ADDENDUM NO. 1

**Administration Building Renovation Re-bid
Compton Community College District**

tBP Project. No. 20987.00

tBP/ARCHITECTURE

ENLARGED SITE PLAN - ACCESSIBLE PARKING SCALE: 1/8" = 1'-0"

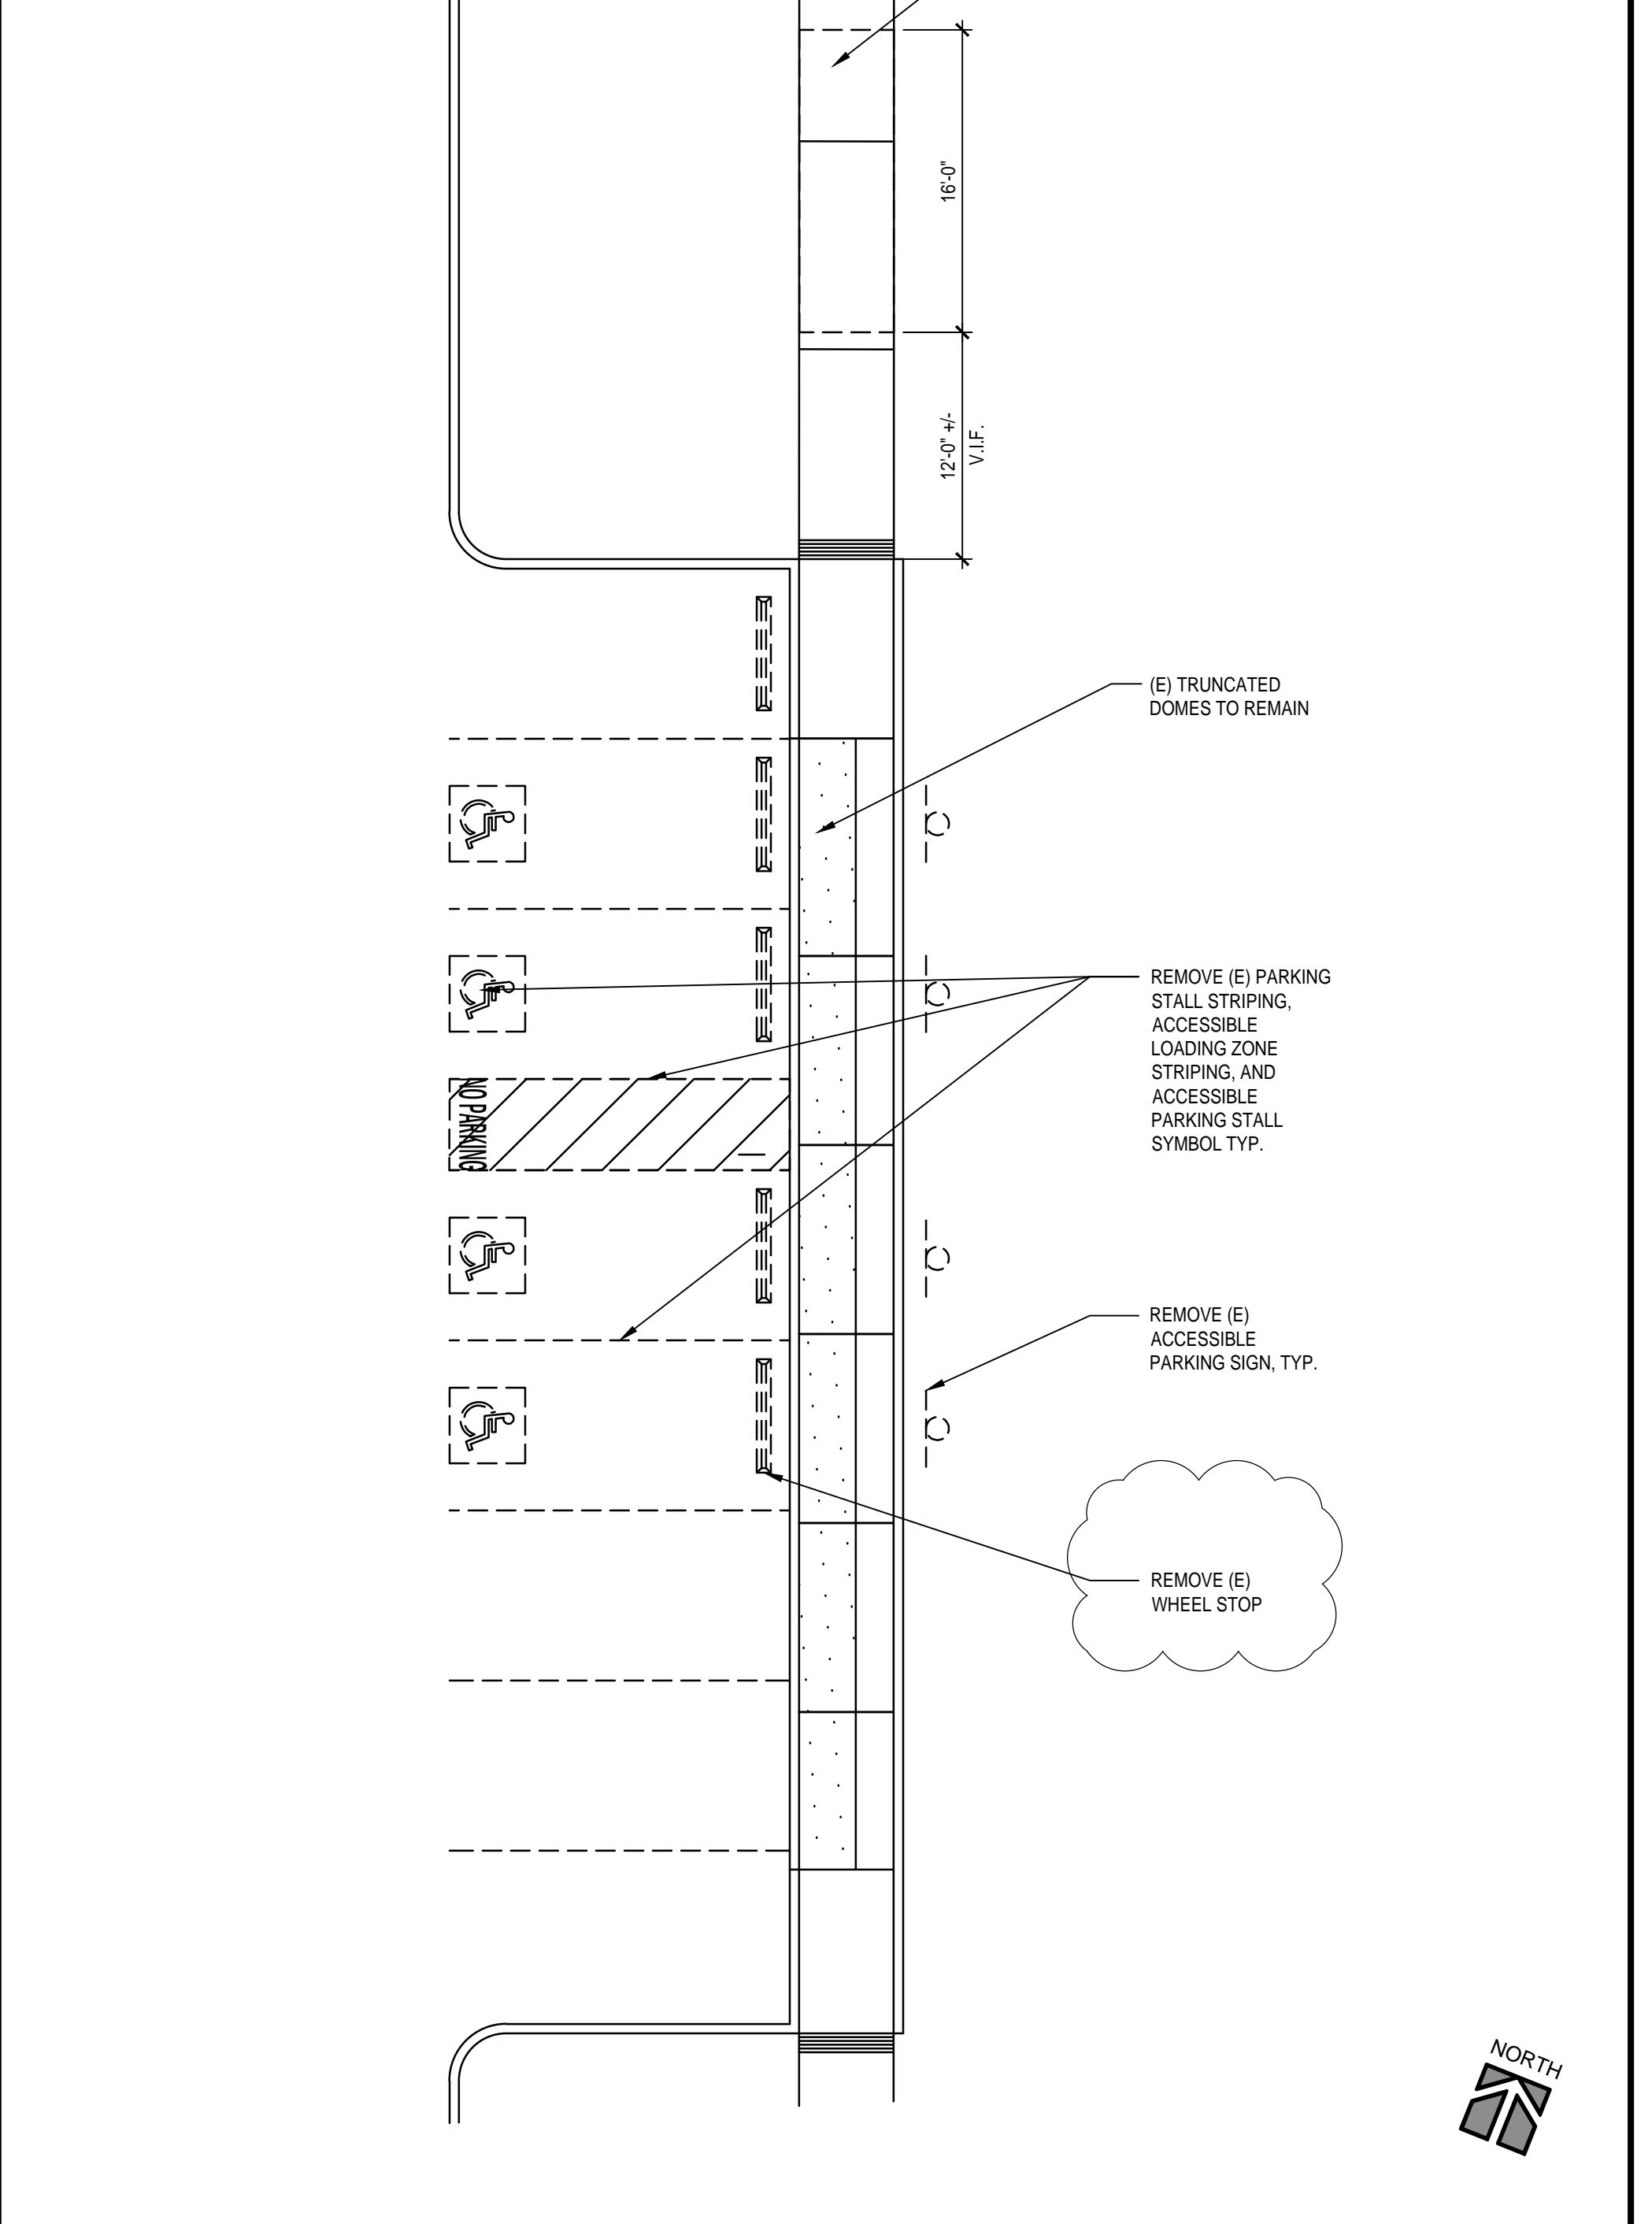
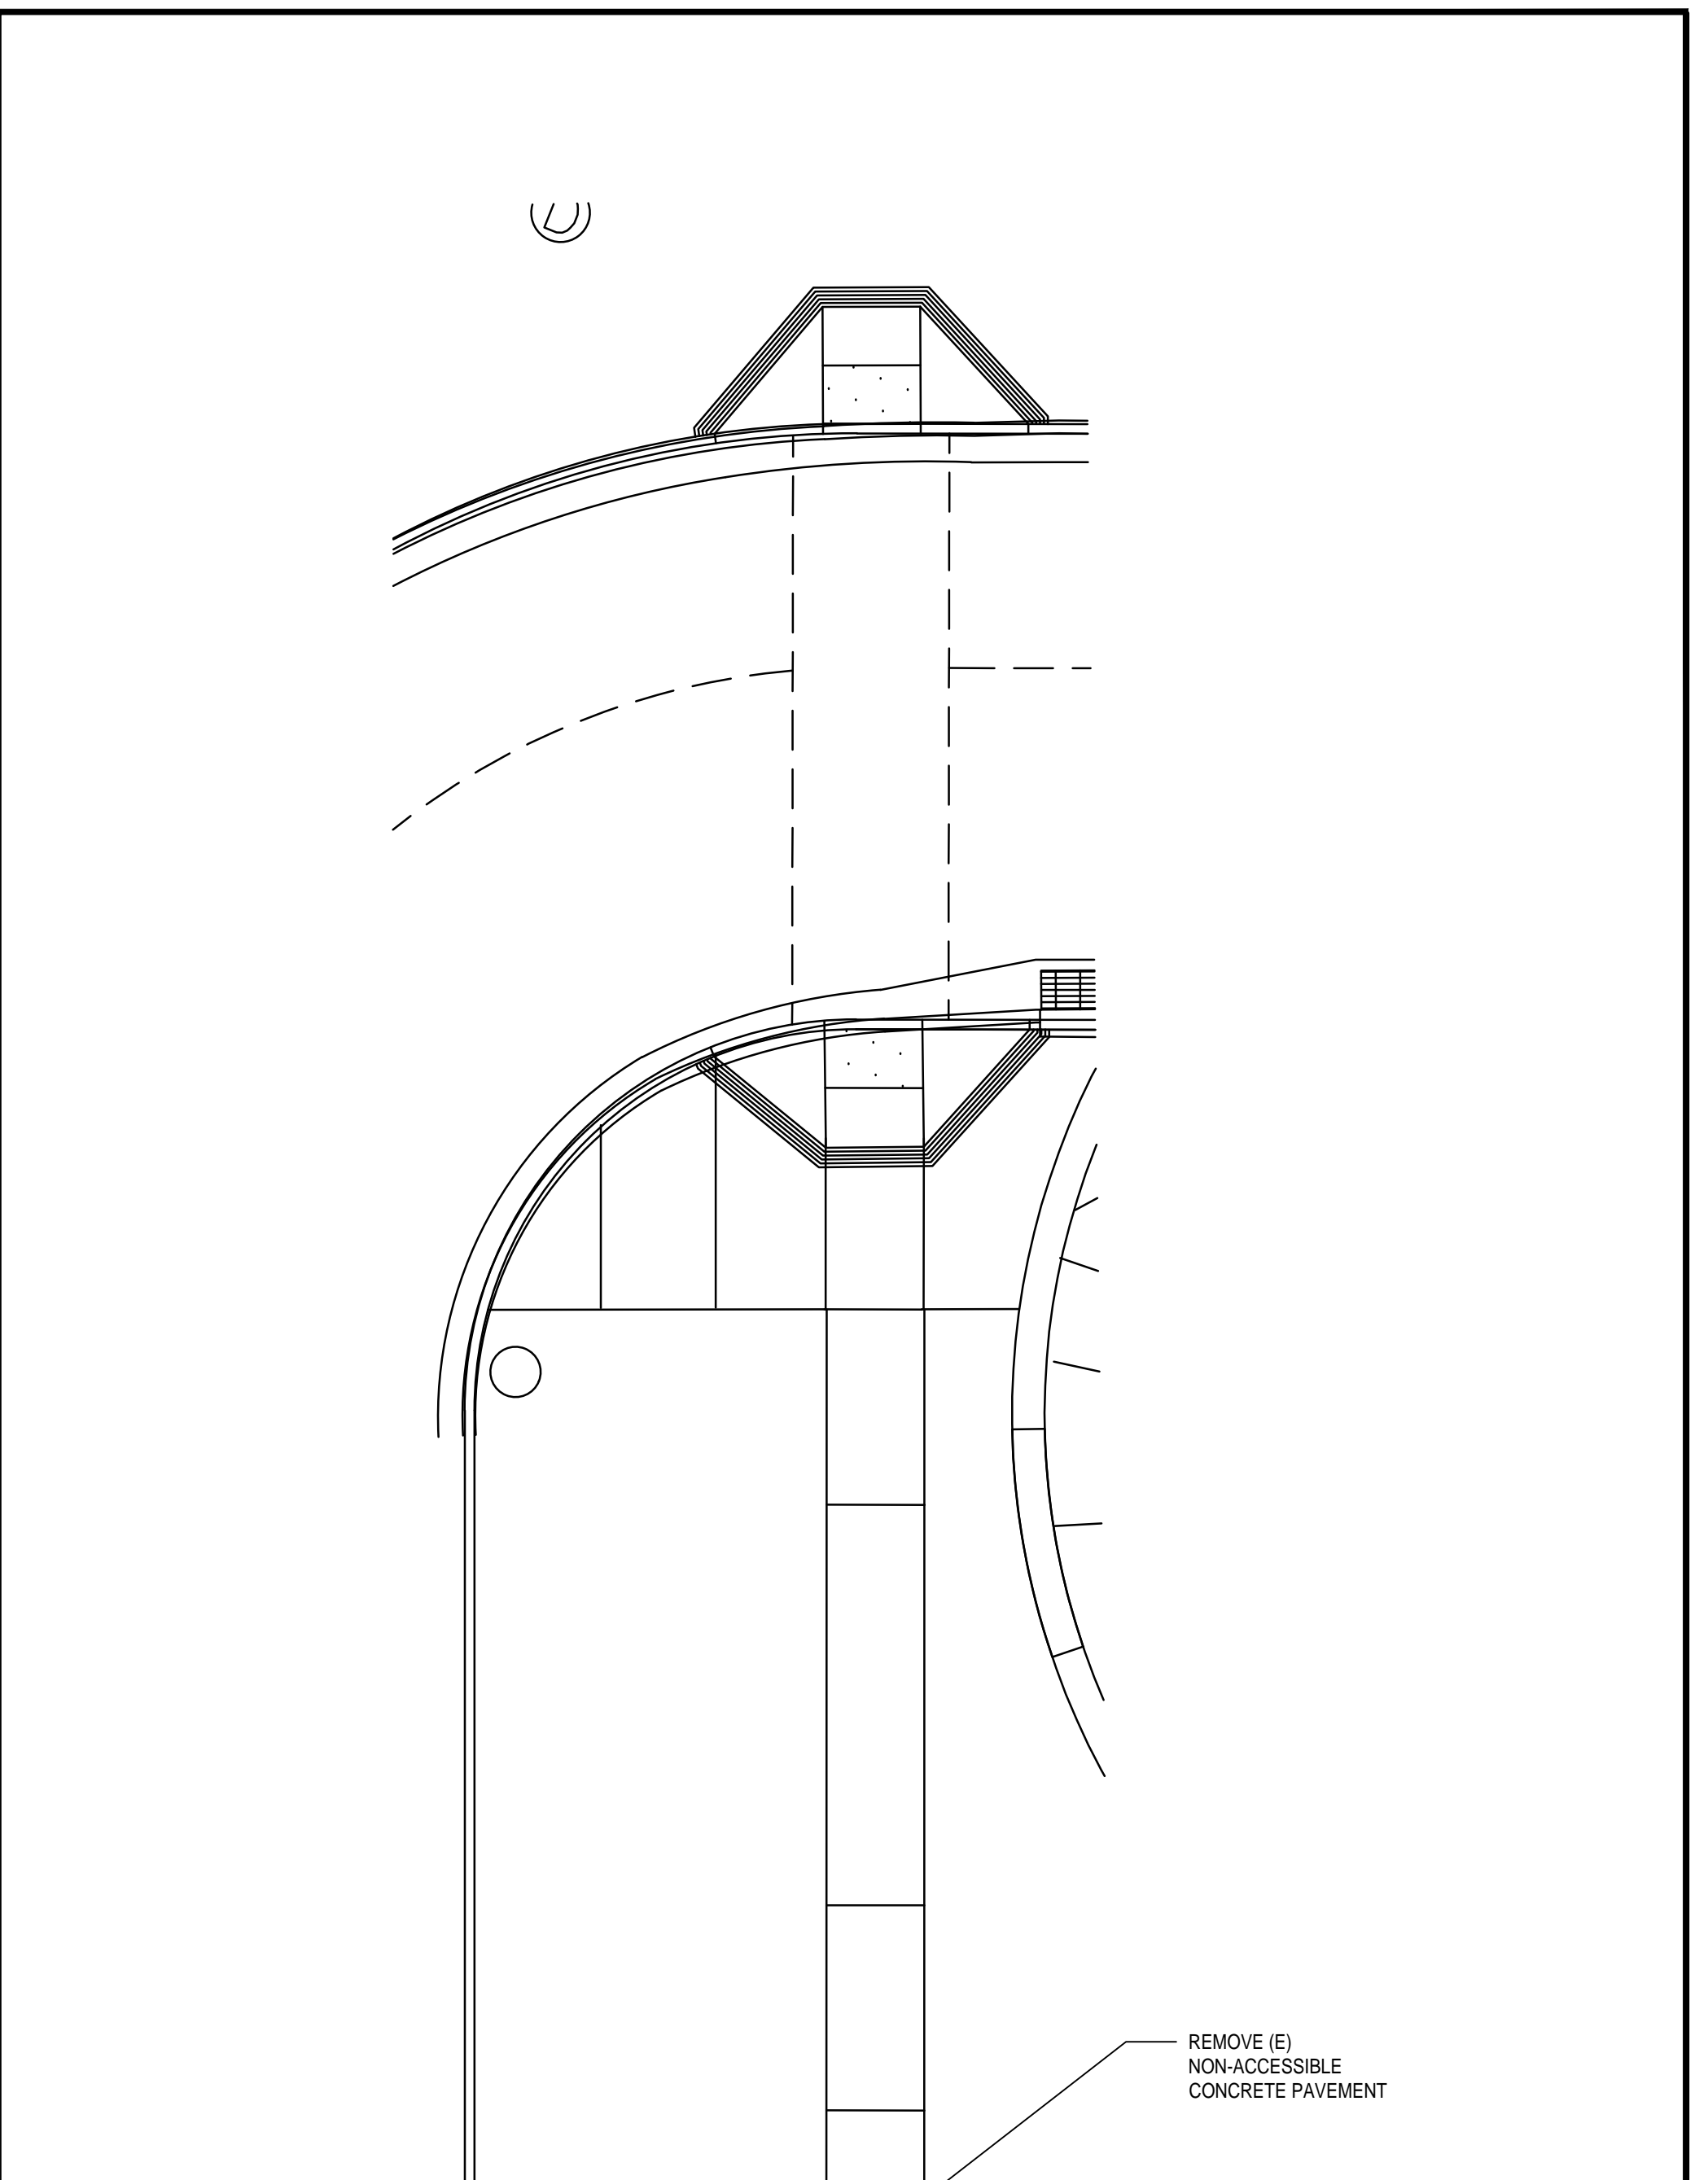
1. Revised SHEET AS-2 SITE DETAILS AND ACCESSIBLE PARKING

a. Included repair and slurry of asphalt area where new ADA parking is re-

- stripped.
- b. Revised all existing wheel stops to be new.
- c. Corrected detail references.
See attached revised Full size sheet identifying revisions included as part of this addendum.
